# City of Richmond

## Report to Development Permit Panel

**File:** DP 19-853070

**Re:** **Application by Eric Law Architect Inc. for a Development Permit at 9091 and 9111 No. 2 Road**

DP19-853070 PLAN 10 **A11**

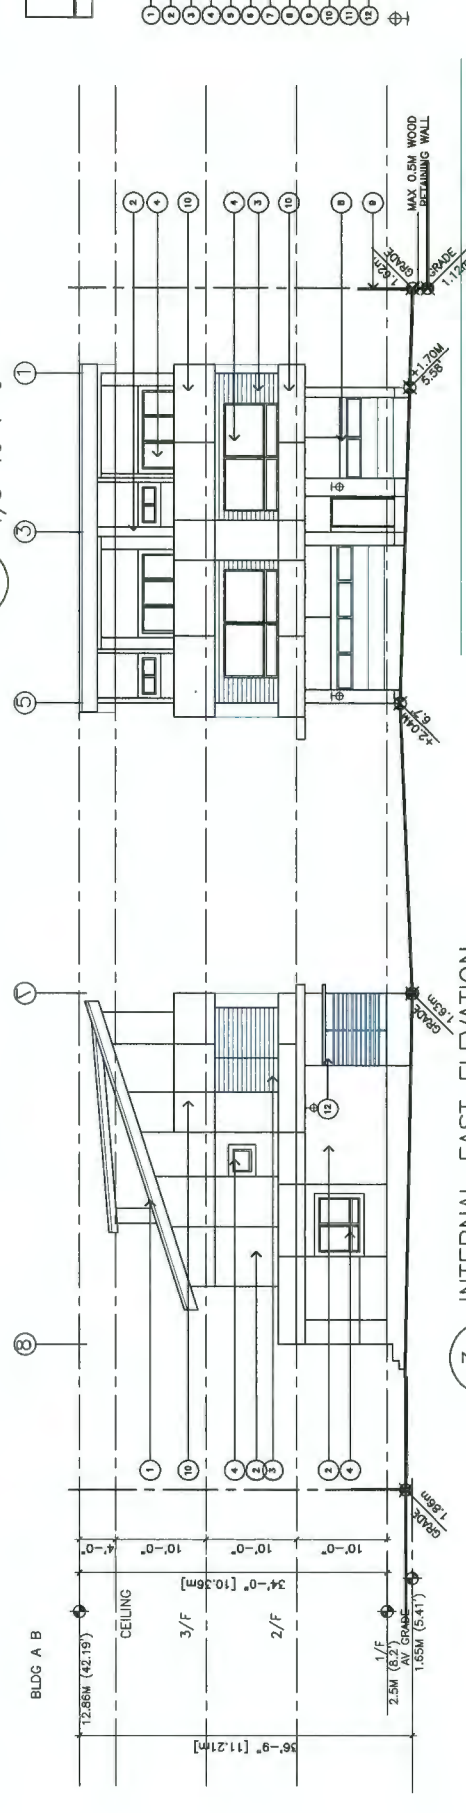
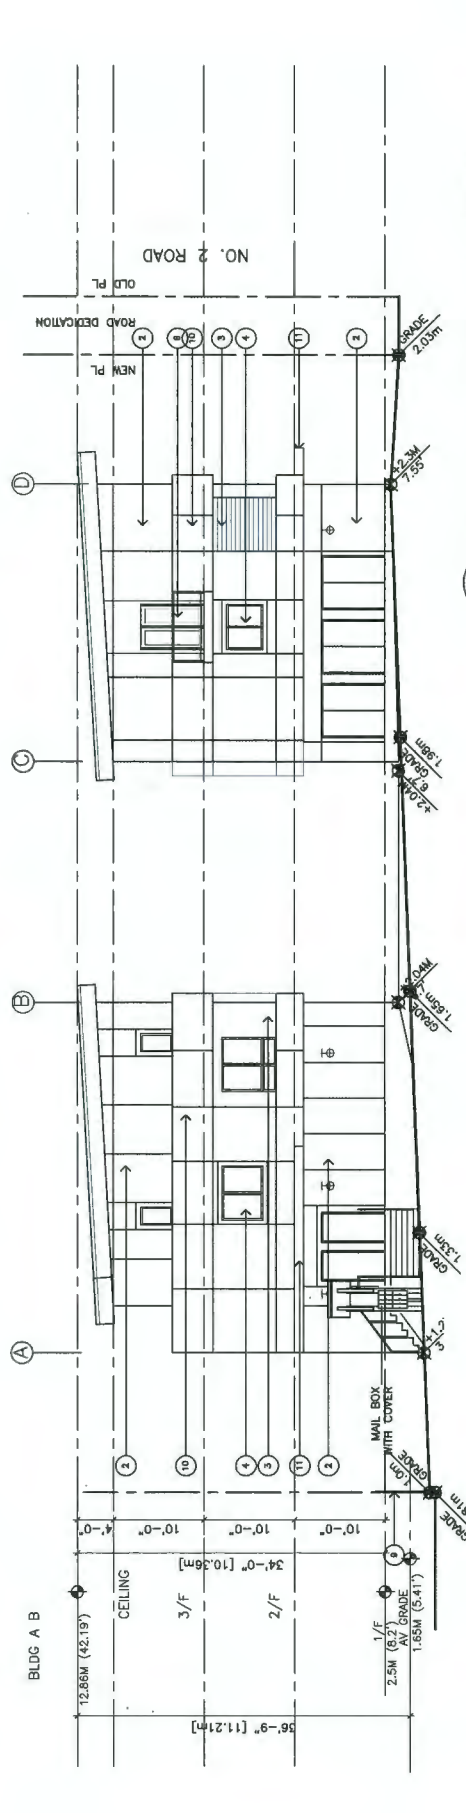
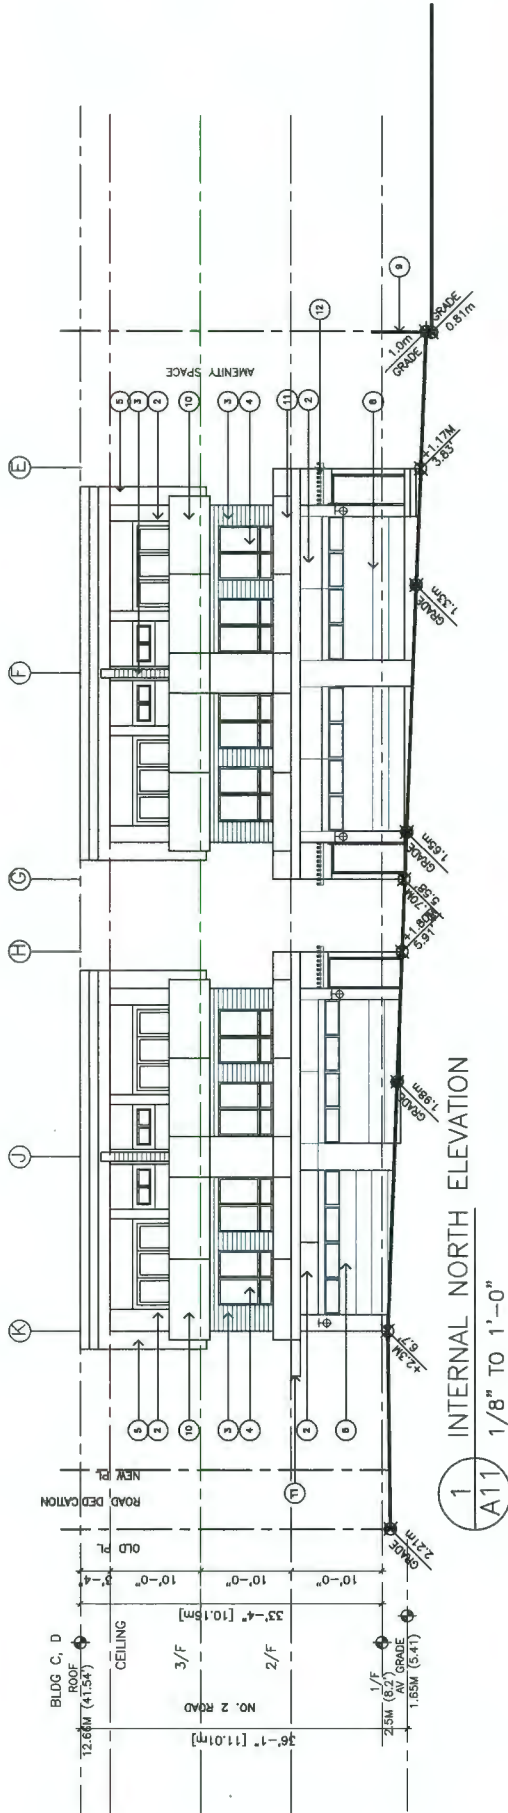
***A recessed reveal joints detail is indicated on A11. This will ensure a clean panel looking building façade.***

1/2" RECESS REVEAL  
 HARDI PANEL

LANDSCAPE PLAN  
DP 19-853070 PLAN 15  
L1

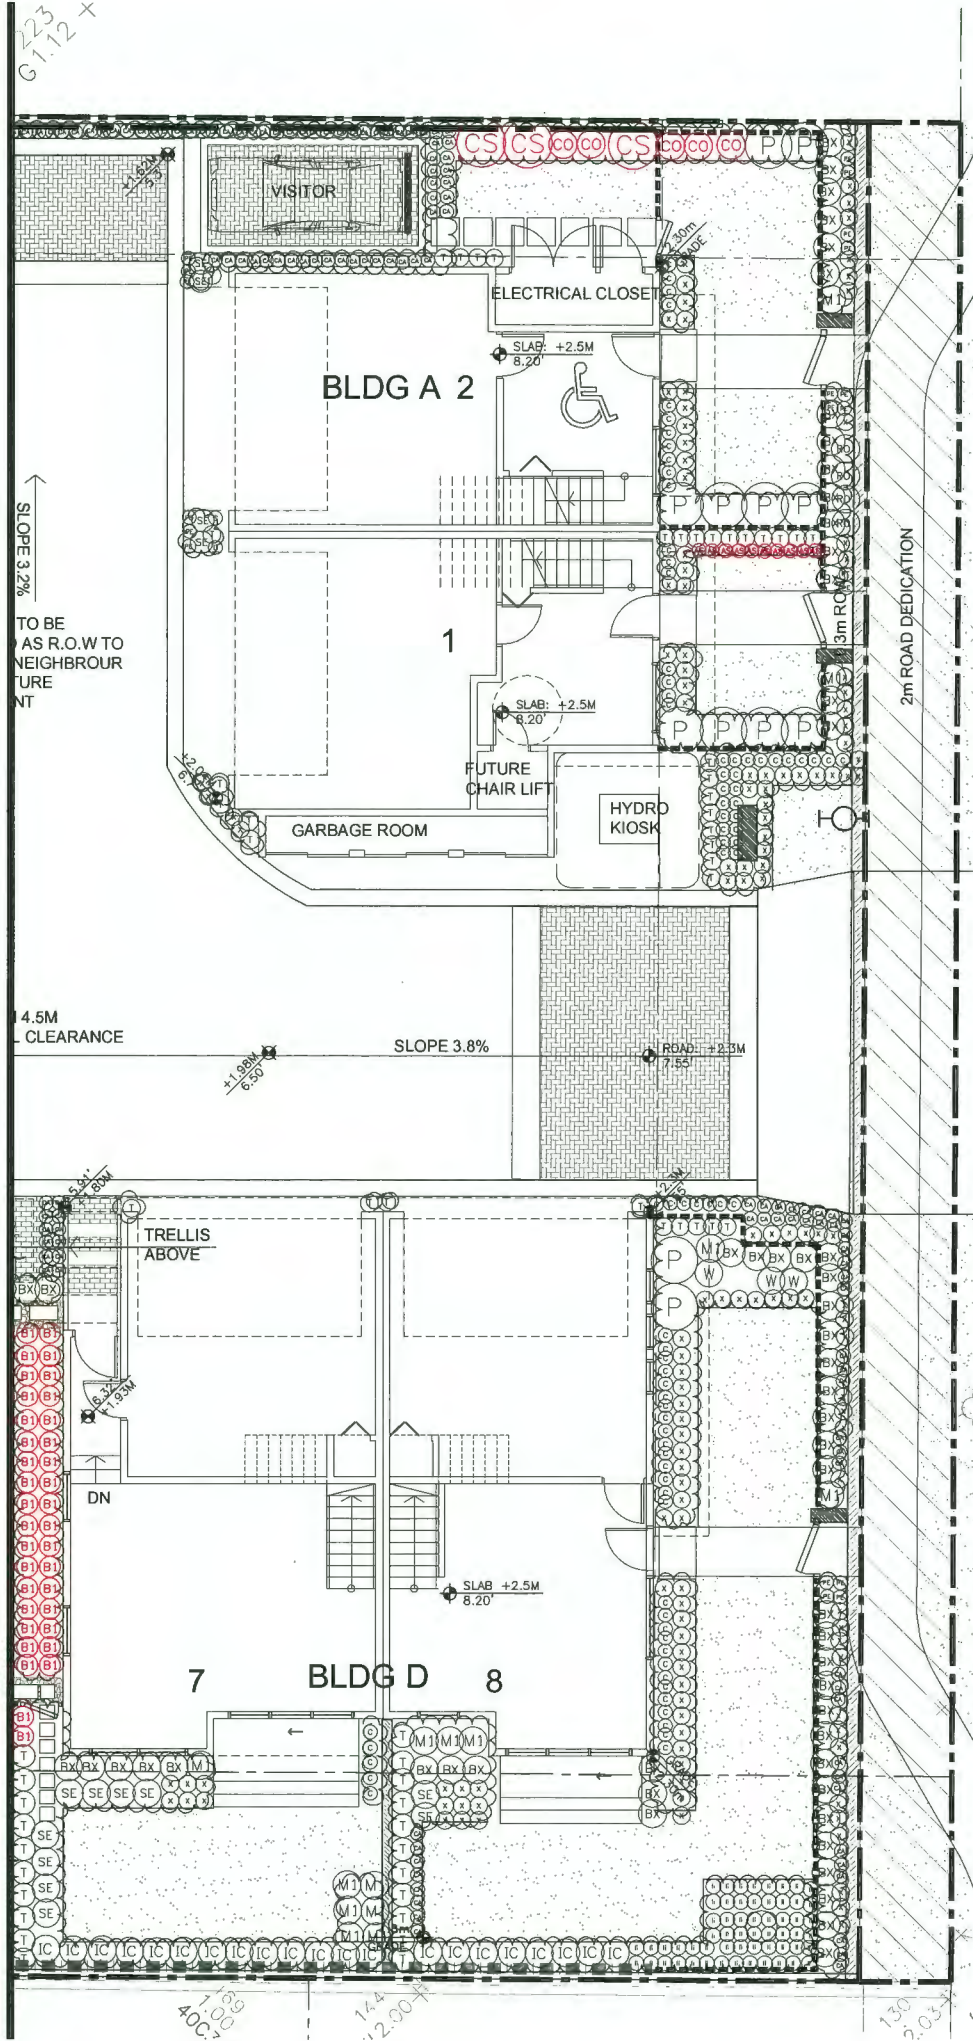
***Design of the outdoor amenity area has been revised to be more cohesive with the model. Please see L1 for your reference.***

DRAWING TITLE:  
TREE MANAGEMENT PLAN

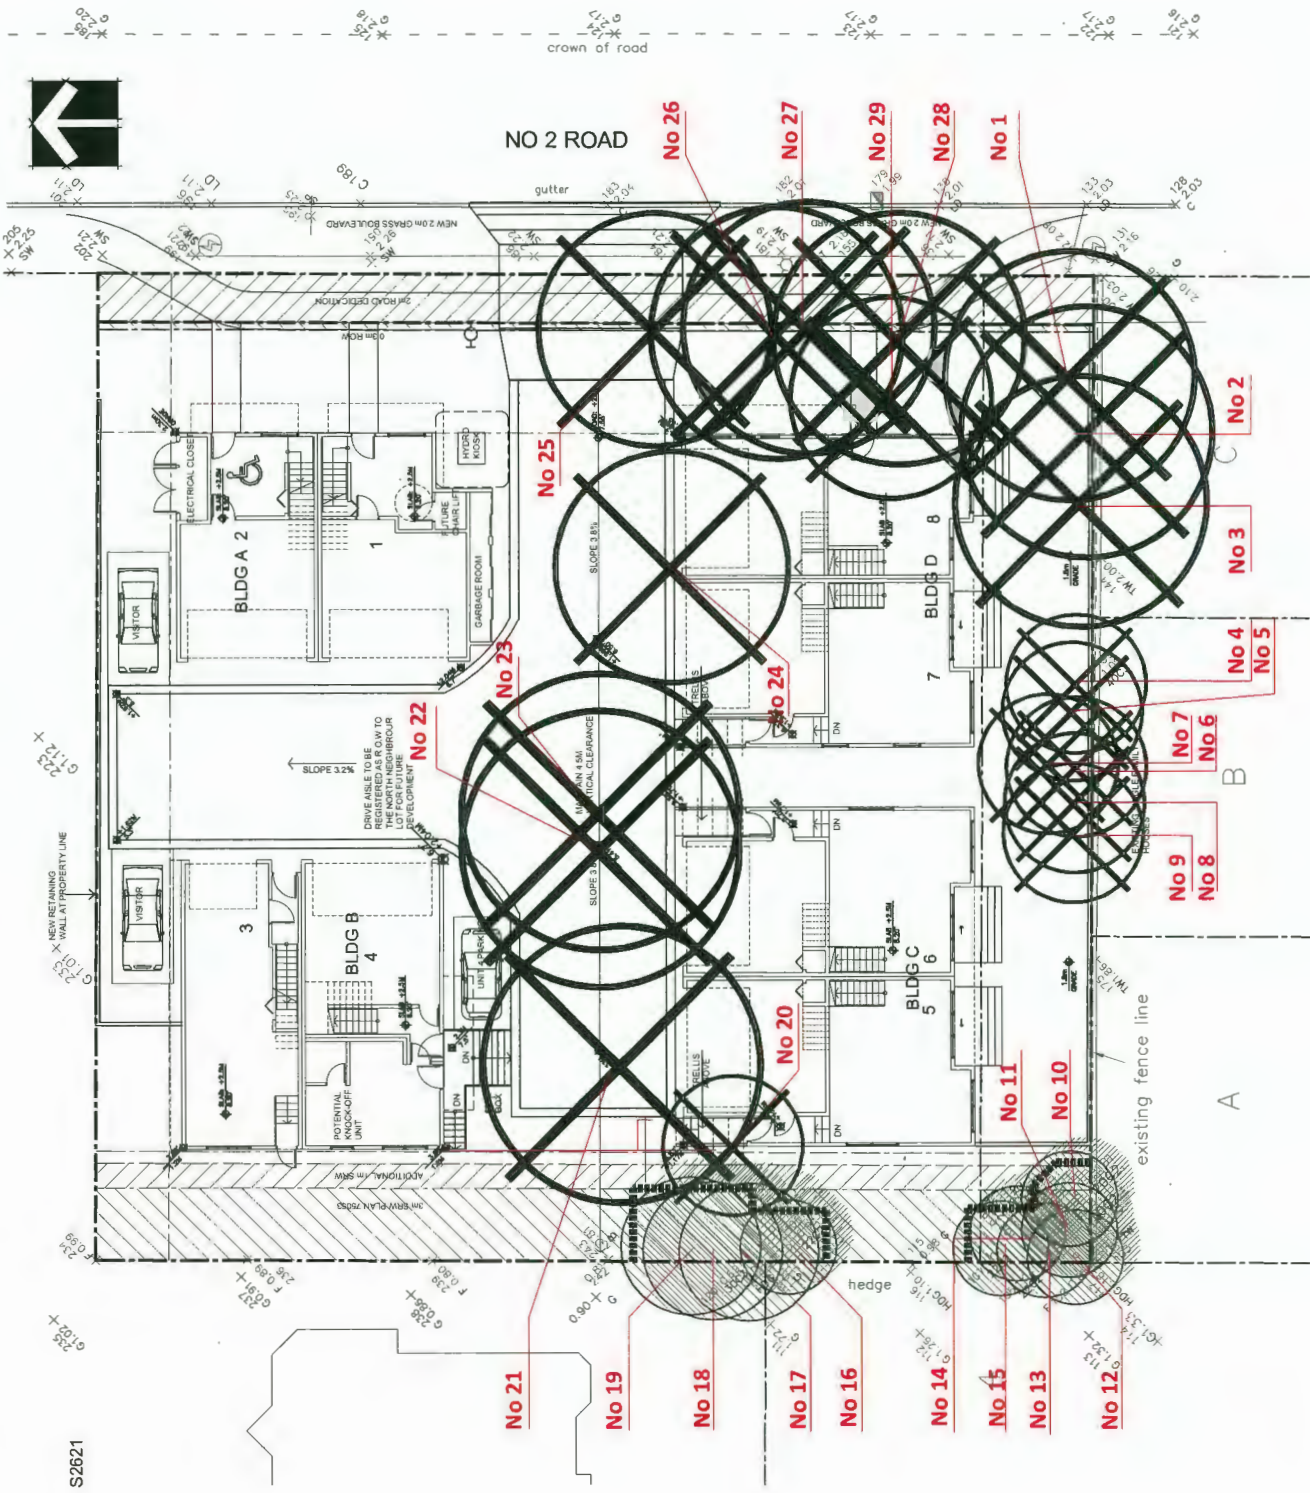
- Four trees previously identified for removal (Tag # 16-19) due to proposed grade changes are now proposed to be retained and protected, as the site plan has been modified to eliminate the grade change along the west property line.

- One of the trees identified for retention (Tag # 1) declined in health and was determined to be at risk of failure. This tree has been removed out of concern for public safety. Replacement trees are required at a 2:1 ratio as per the OCP.

- The revised proposal includes retention of 10 on-site trees, removal of 19 on-site trees, and planting of 21 replacement trees. A \$12,500 contribution to the City's Tree Compensation Fund in lieu of replacement trees that cannot be accommodate on the development site was secured through the rezoning application.
